Planning Application under Section 16 of the Town Planning Ordinance for Proposed Residential Institution (Student Hostel) at Middleton Towers, 140 Pokfulam Road (RBL No. 825 RP) (Application No. A/H10/98)
Submission of Responses to Comments (2nd Batch)

**S.16 Planning Application for Proposed Residential Institution (Student Hostel) in “Residential (Group C)”
with a minor portion within “Green Belt” Zones at Middleton Towers, 140 Pok Fu Lam Road (Rural Building Lot No. 825 RP)
and adjoining Government Land, Pok Fu Lam, Hong Kong**

Responses to Departmental Comments (2nd Batch)

Appendix 2.1 Water Main Records

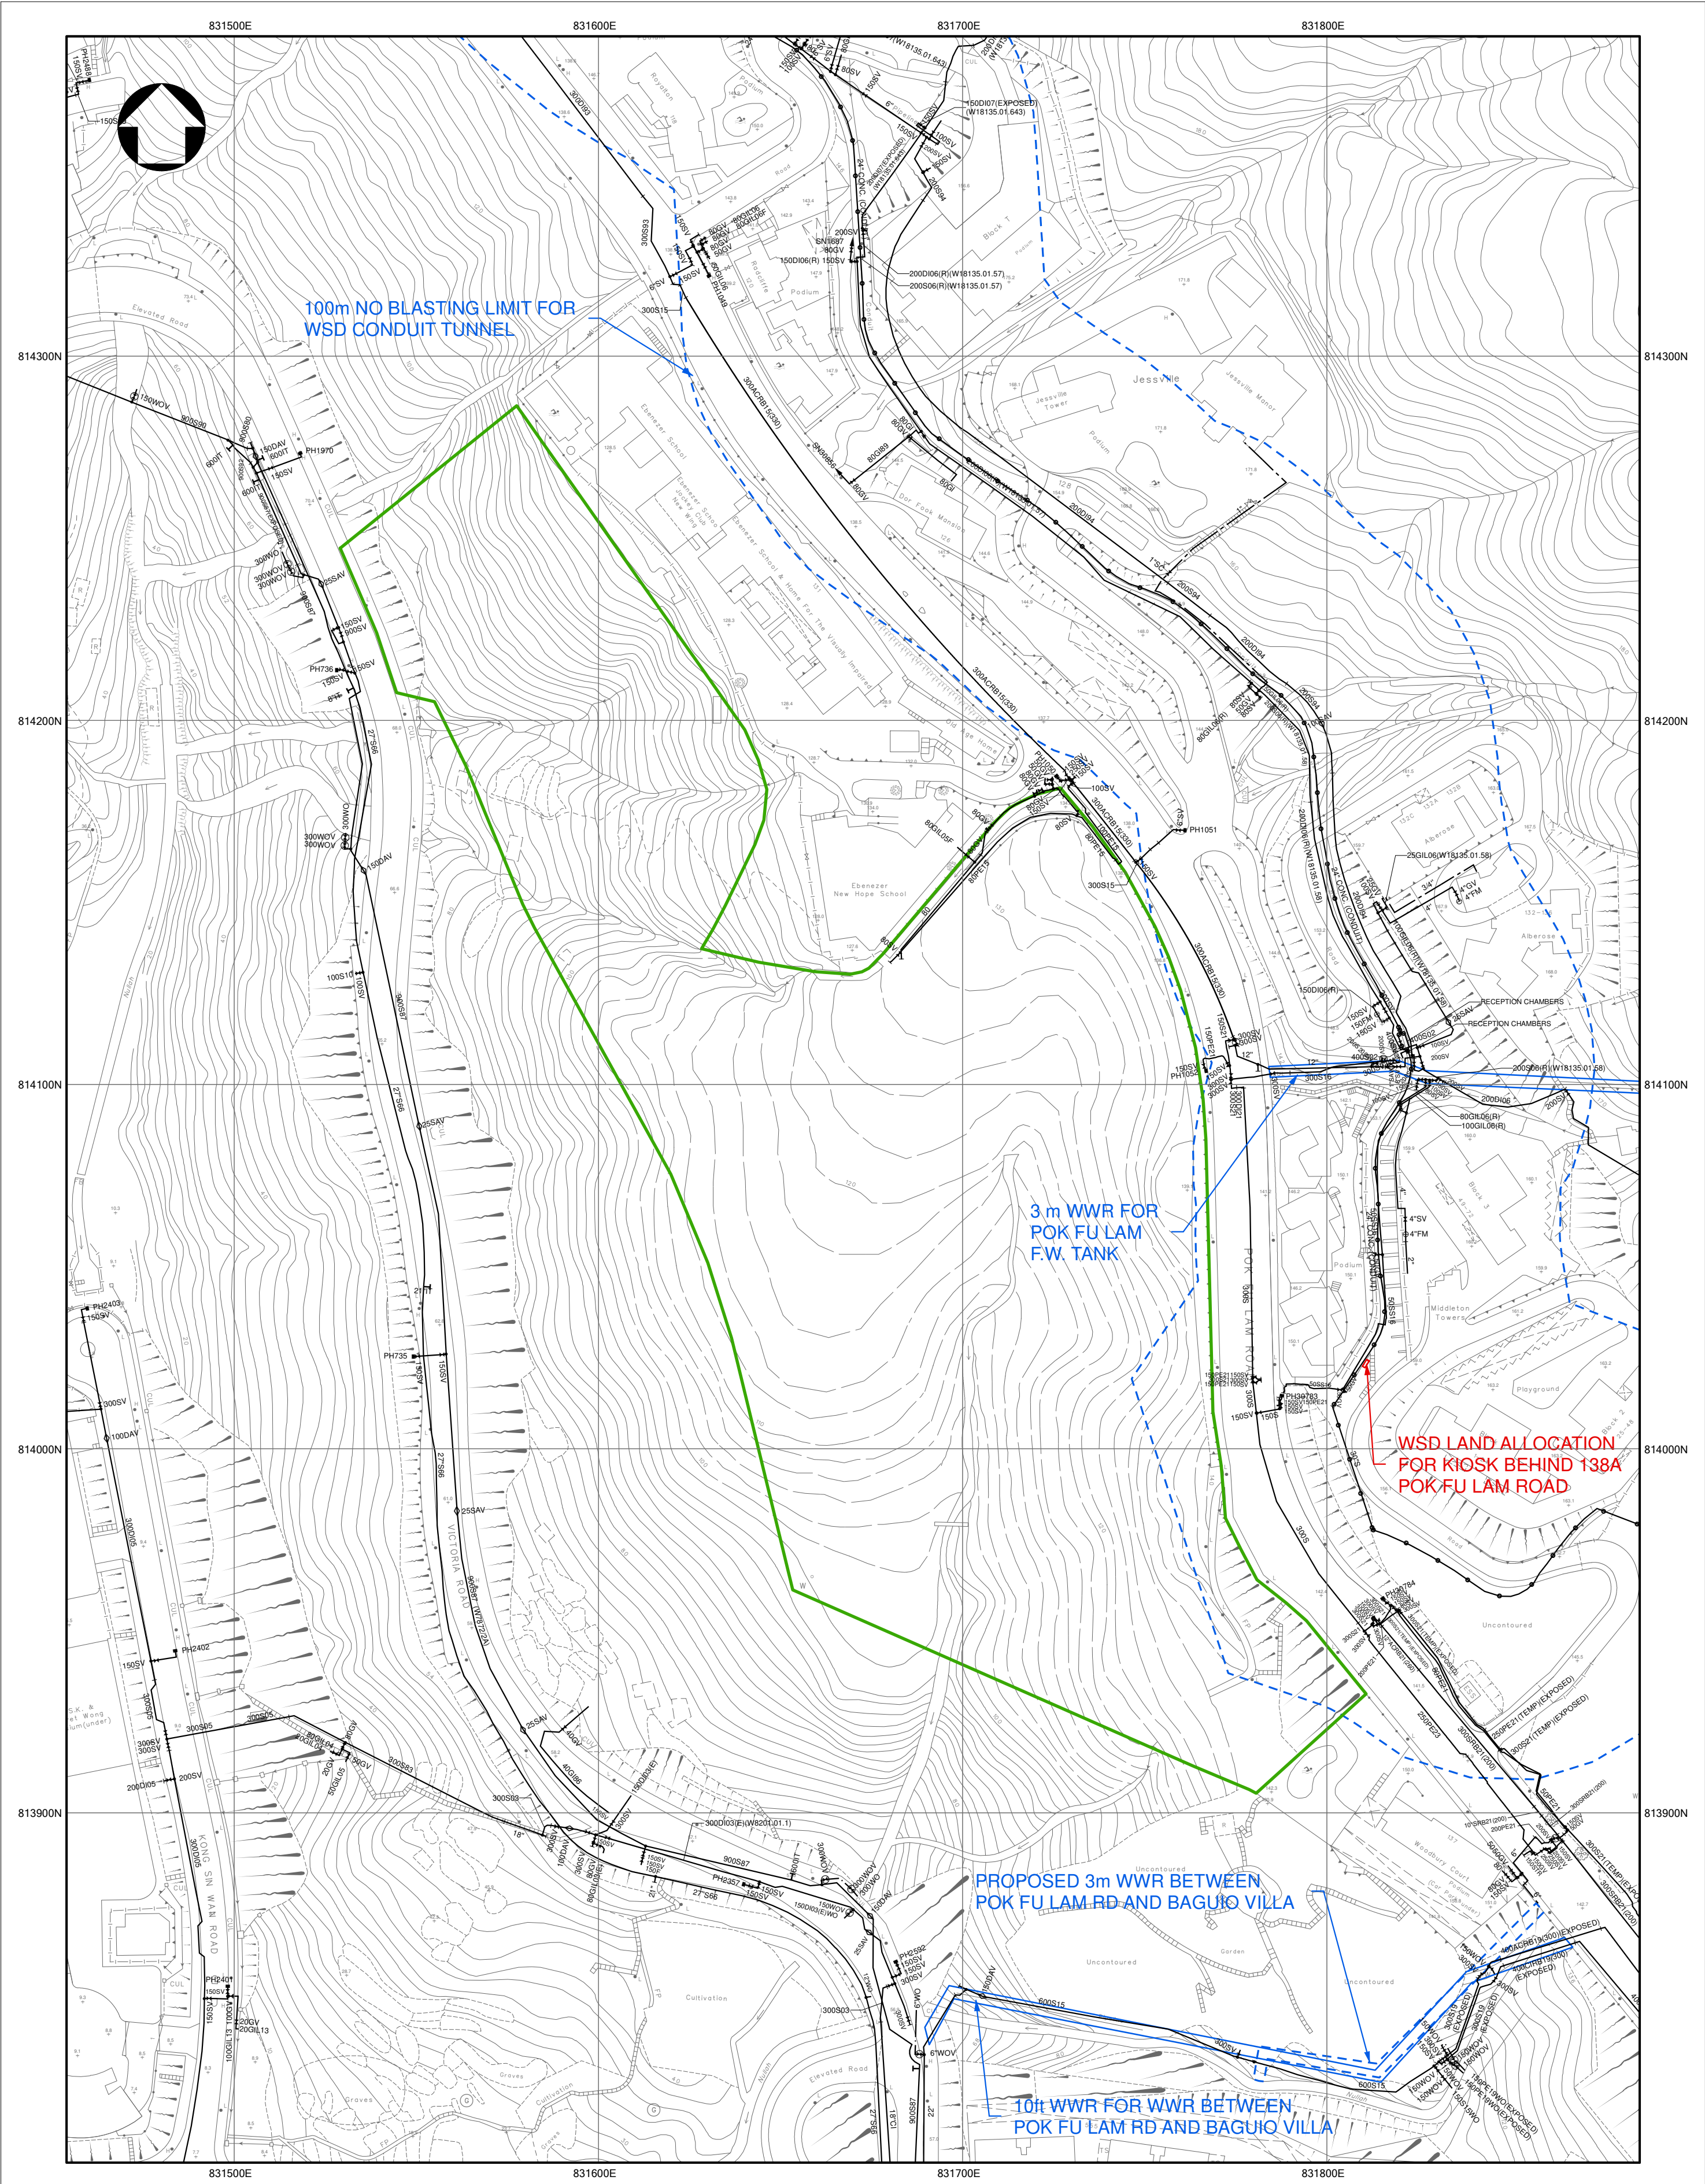
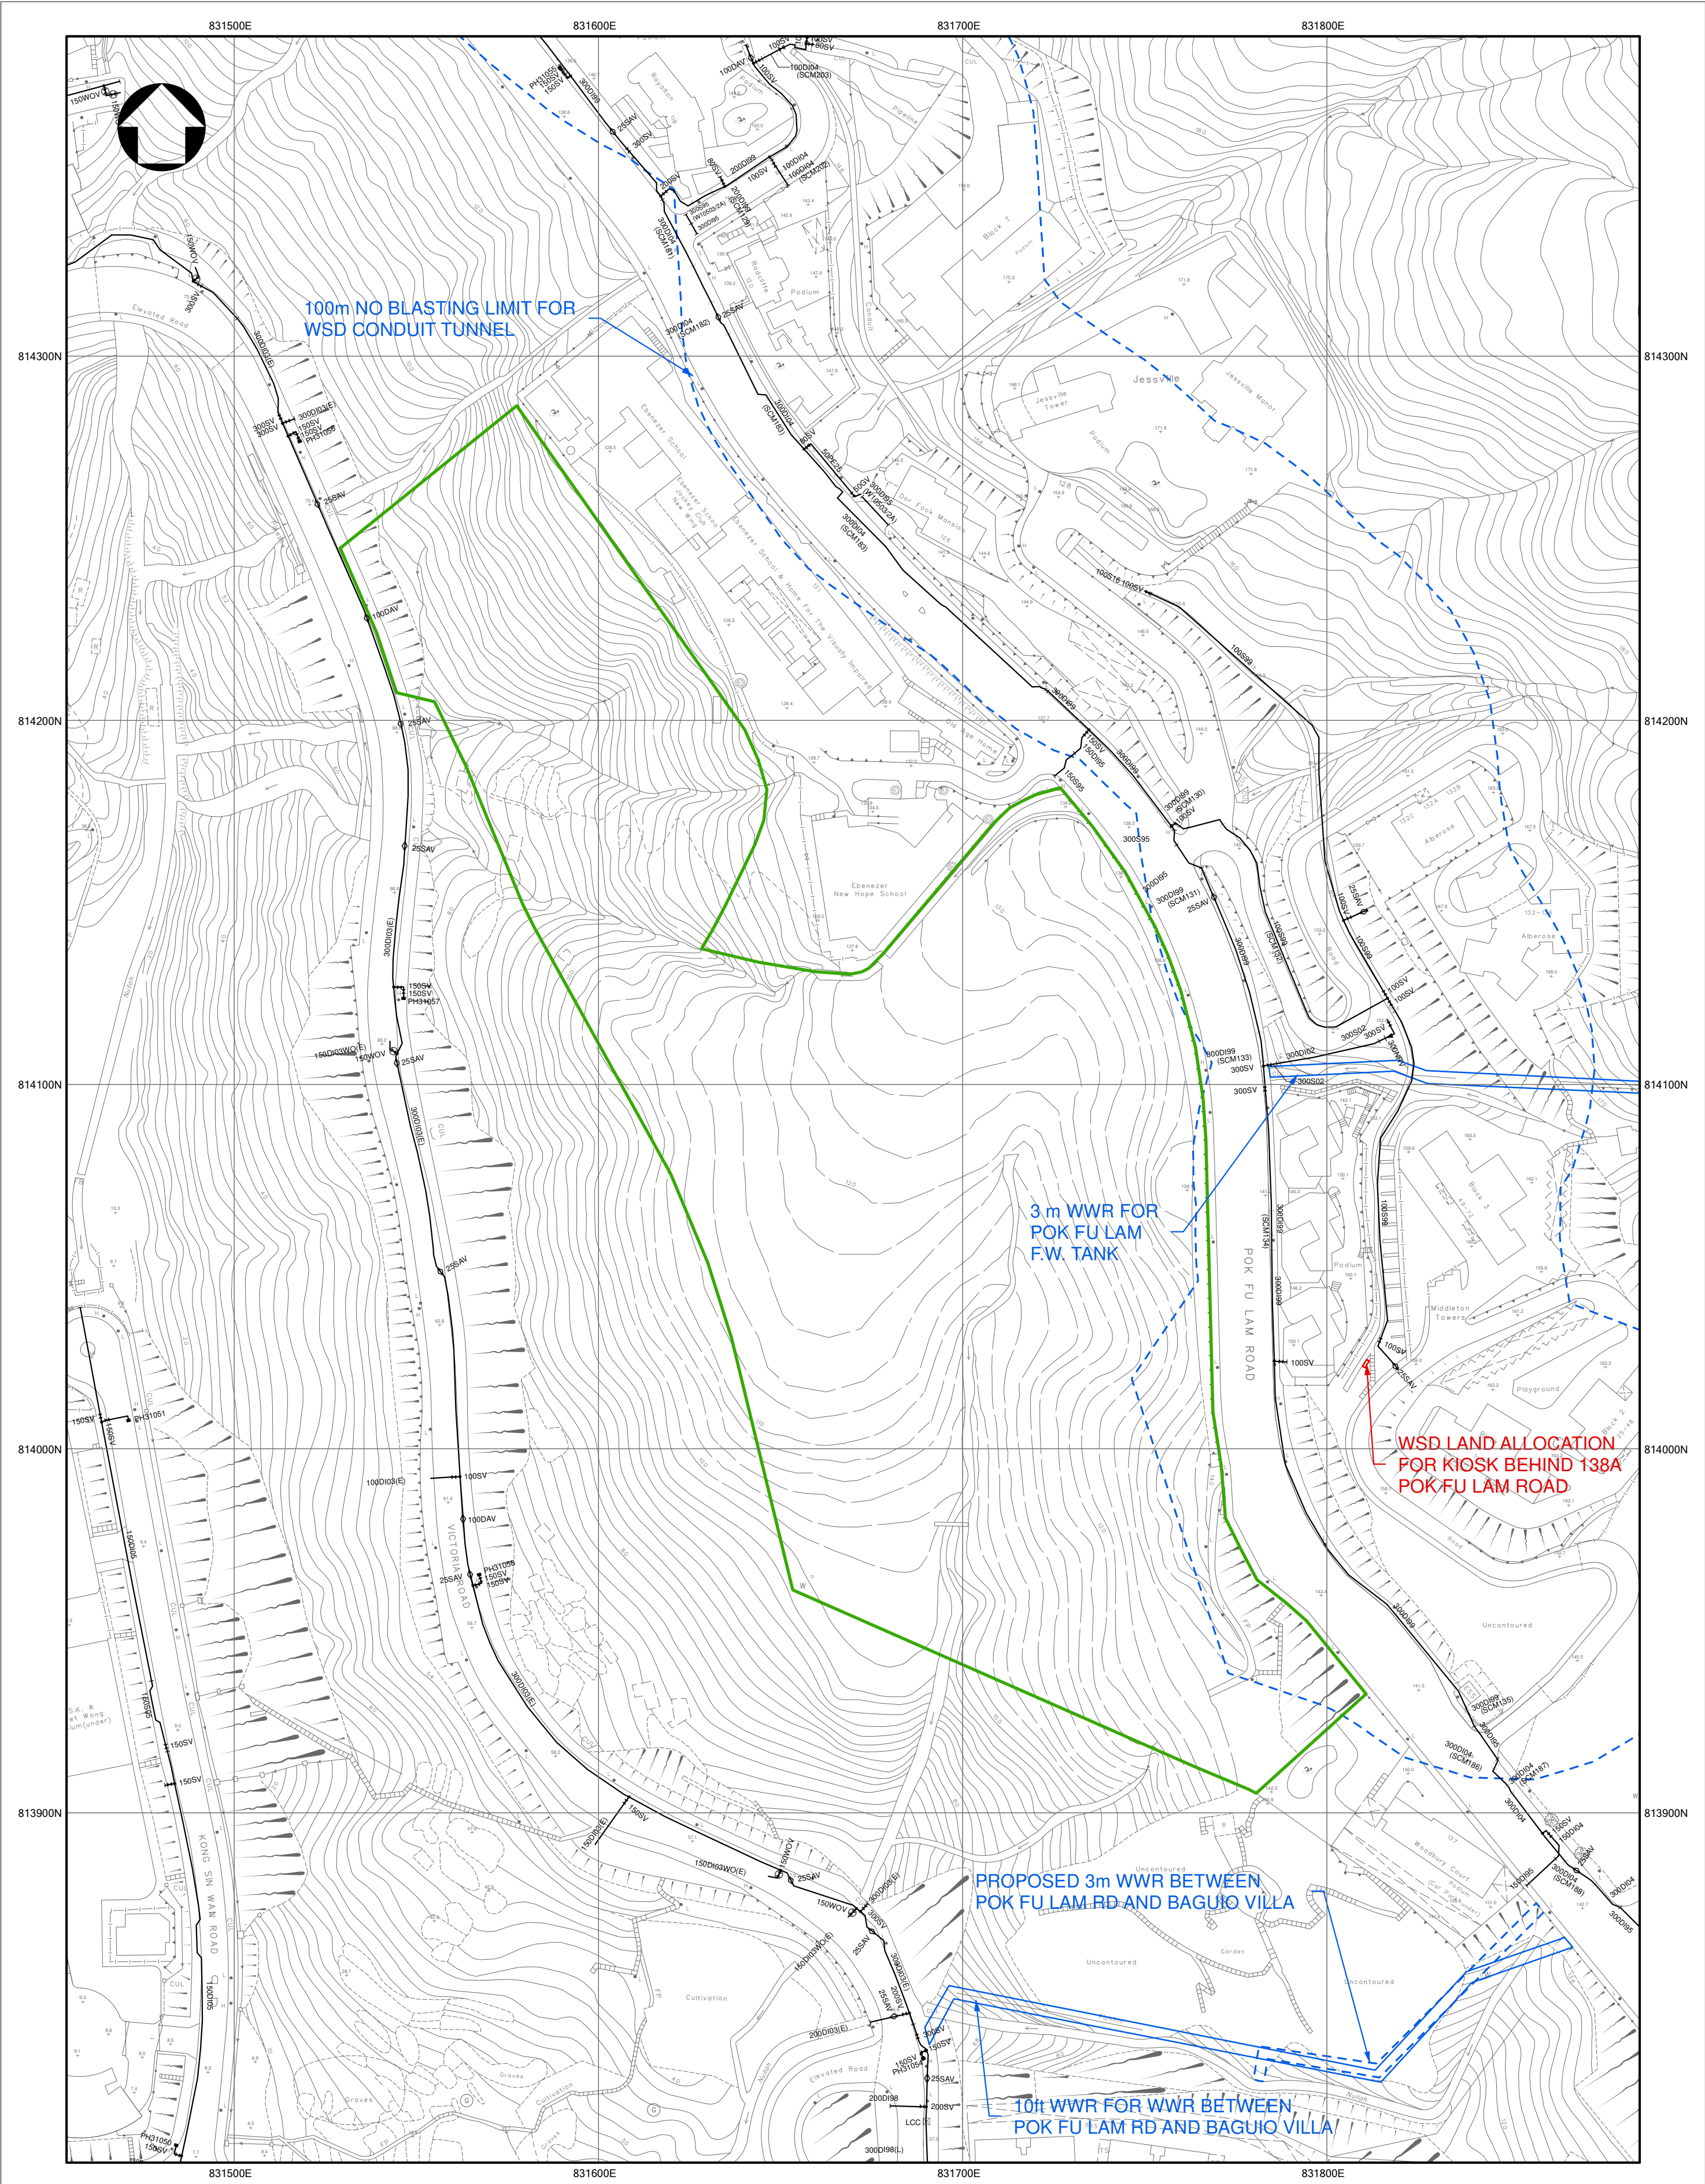
1.1.	Please note the comments from water supply system planning point of view:- Our comment no. 3 "For salt water unit demand, please adopt our latest ceiling value of 100 l/h/d (per residential population)....." provided in our email to you on 15 April 2026, was not addressed in this submission. Please revise.	Noted and updated accordingly.

1.2.	It is noted in this application that the application site, which is currently used for staff quarter purpose, is proposed to transform into student hostels by internal re-partitioning. Please provide the net increase / decrease in the fresh water / flushing water demands due to the proposed re-development, for consideration.	The net increase / decrease in the fresh water/ flushing water demands were included in the section 2.3 in the submitted WSIA for your perusal.

2.5.2 Regarding the fresh water supply, there is an existing 100mm fresh water main located to the northwest of the Subject Site, which tees off from an existing 200mm fresh water main. The existing development currently utilizes approximately 17% of this 200mm main. While the fresh water main arrangement for the Proposed use will remain unchanged from the existing configuration, the Proposed Use is projected to utilize 66% of the existing 100mm fresh water main's capacity.

2.5.3 Regarding the flushing water supply, an existing 100mm flushing water main is located to the west of the Subject Site. The saltwater main arrangement for the Proposed Use will connect to this existing 100mm main. Approximately 18% of the existing 100mm saltwater main's capacity will be utilized by the Proposed Use.
